## Subdivision – Land Use Report for a Living 1, 2 and 3 Environment

File reference **SL 2100055**

Applicant **Onoke Heights Ltd**

Report Date 20 October 2023

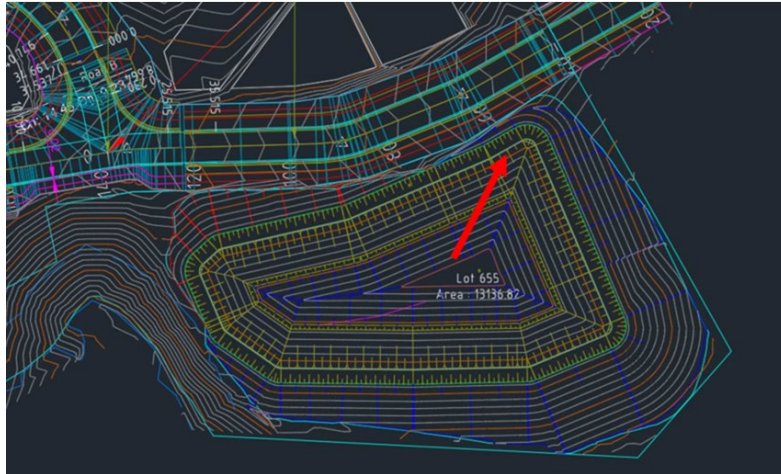
Climate change does need to be factored as required by the WDC DP.

If not complying with WDC ES 2022, then the designer will need to demonstrate that development does not increase downstream flooding risk.

We also discussed that it is not acceptable to rely on other development conditions as each development must be considered separately to take into consideration the differences in the development and the receiving environment.

We have decided to agree in principle to the increase in detention required to accommodate the 80% predevelopment request, attached is a brief summary of the effects and we will update the plans and more detailed bits of information like the drawings if that's acceptable for this change as part of the EPA once consent is granted.

A summary of the changes was provided. The ponds footprint is the same shape as in the current plans just stretched a bit uphill mainly in the direction of the arrow to get the additional volumes required to achieve the additional mitigation, the slopes batter benches etc remain unchanged.

Subject to provision of further detail and calculations at Engineering Design stage, the response is accepted. This matter is considered closed.
